Subject: UniStar Nuclear Energy, NRC Docket No. 52-016
Response to Request for Additional Information for the
Calvert Cliffs Nuclear Power Plant, Unit 3,
RAI 384, Fire Protection Building Ventilation System

**Response to NRC Request for Additional Information
RAI 384, Question 09.04.03-1,
Fire Protection Building Ventilation System,
Calvert Cliffs Nuclear Power Plant, Unit 3**

Figure 1

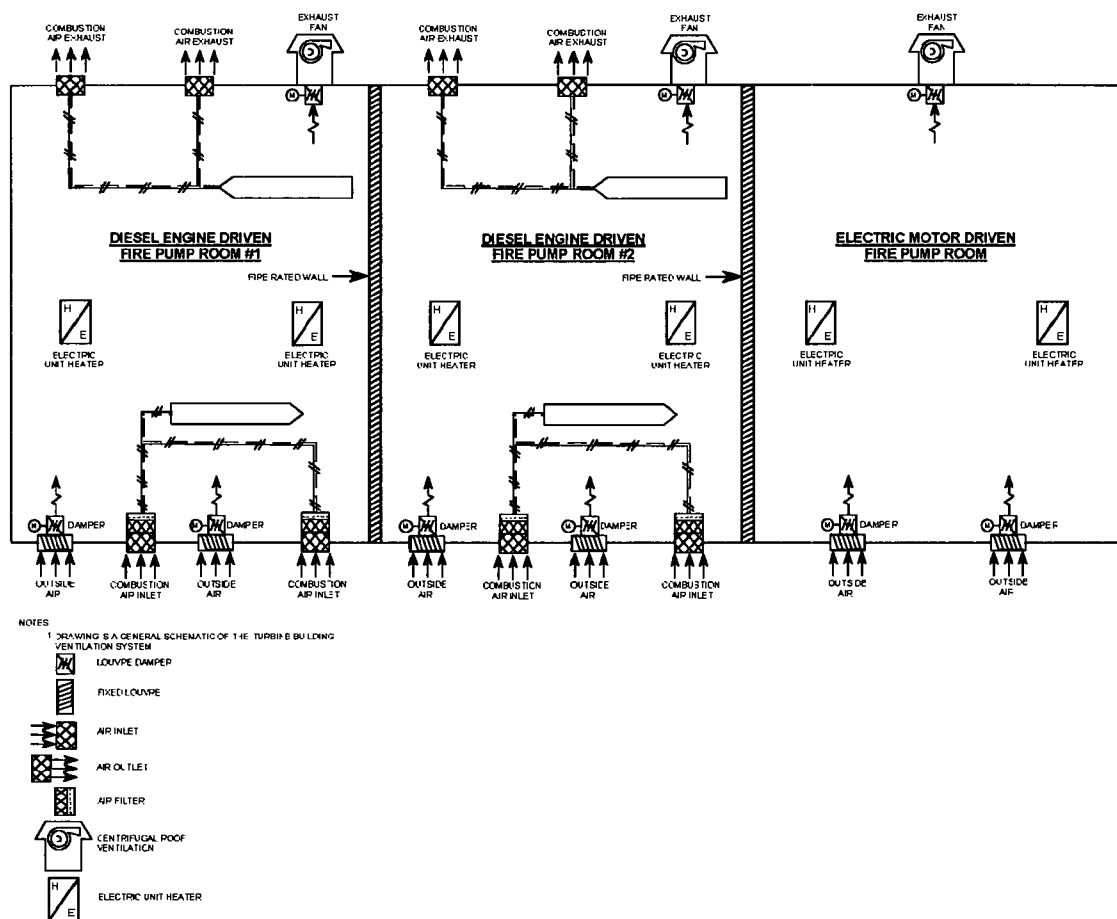
Also provide a system flow diagram or piping and instrument diagram of FPB Ventilation System showing the key features of major components.

The Fire Protection Building Ventilation System provides an acceptable environmental condition for the operation of the Fire Protection System Equipment, including the diesel engine driven pumps located inside of the Fire Protection Building (FPB). Figure 9B-20, CCNPP Unit 3 Fire Barrier Location, Fire Protection Building Plan View at Elevation 85'0, provides schematic representation of the Fire Protection Building. This figure is updated to be consistent with the general arrangement fire protection storage tanks and buildings drawing. Figure-1 depicts the Fire Protection Building Ventilation System components. This ventilation system also provides safe and satisfactory indoor environmental conditions to support personnel access to the two diesel driven pump rooms and electric motor operated pump room. The Fire Protection Building Ventilation System, in the two diesel engine driven pump rooms, is a Nonsafety-Related augmented quality (NS-AQ) system designed to meet Conventional Seismic-I requirements. The ventilation system in the electric motor driven pump room is a Non-Seismic system. Each pump room contains independent components of the ventilation system to maintain the temperature in their respective rooms.

In the event of loss of offsite power (LOOP) or Station Blackout (SBO), a self-contained Standby Diesel Generator (SDG) provides AC power supply to the FPB ventilation system, heating system, and building normal and emergency lighting systems to the two diesel driven fire pump rooms. The SDG is a Nonsafety-Related augmented quality system designed to meet the Seismic requirement of Conventional Seismic-I. The SDG will be functional and provide power to the FPB ventilation system, heating system, and building normal and emergency lighting systems after a seismic event and loss of power to FPB. Based on the day tank fuel capacity, the Standby Diesel Generator will be able to provide power for up to 24 hours to maintain FPB room temperature within the design limits. The SDG is required to operate a minimum of 8 hours upon total loss of AC power to the FPB and when the diesel fire pump is running, to supply water to mitigate fire in accordance with the requirement of RG 1.189, Section 3.2.2.

INSERT G →

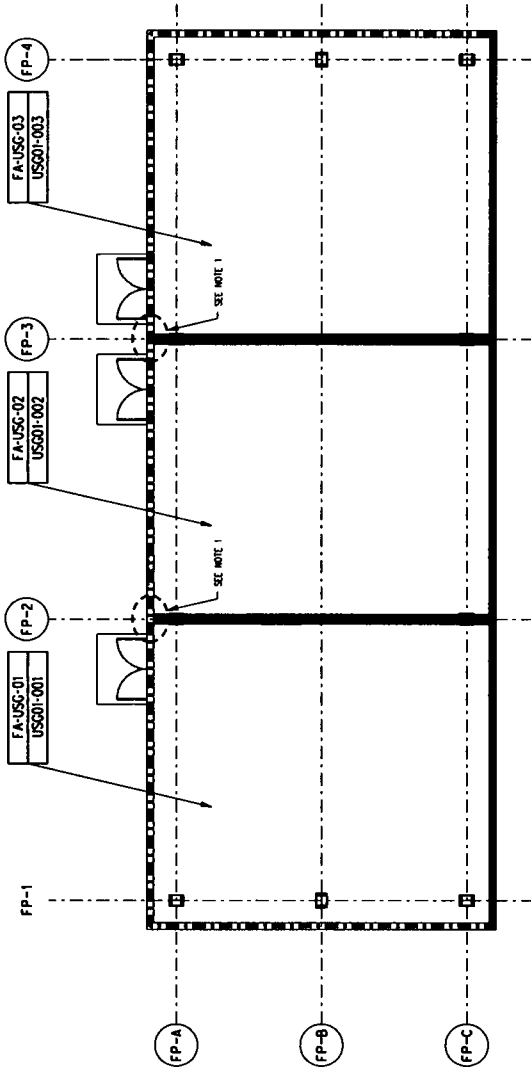
CC3-13-0077	9.4.16.1, 9.4.16.2.1, 9.4.16.2.3, 9.4.16.3, 9.4.16.4, 9.4.16.6, Table 9B-2, Appendix 9B, Figure 9B-20	Incorporate COLA markups associated with the response to RAI 384.	Requirements for the Standby Diesel Generator for the Fire Protection Building Ventilation System as part of RAI 384 Q 02.05.01-70.
CC3-13-0077	14.2.14.14	Incorporate COLA markups associated with the response to RAI 384.	Requirements for the Standby Diesel Generator for the Fire Protection Building Ventilation System as part of RAI 384 Q 02.05.01-70.
Part 10 – ITAAC			
CC3-13-0031	2.4-9 Item 1	Incorporate COLA markups associated with the submission of CCNPP Unit 3 COLA Rev 9 for consistency with U.S. EPR DC Rev 4 ⁶ .	Format and wording changes are made as part of the submittal of the CCNPP Unit 3 COLA Rev 9.
CC3-13-0077	2.4-9 Item 1	Incorporate COLA markups associated with the response to RAI 384.	New ITAAC parts are added for the Standby Diesel Generator for the Fire Protection Building Ventilation System as part of RAI 384 Q 02.05.01-70.
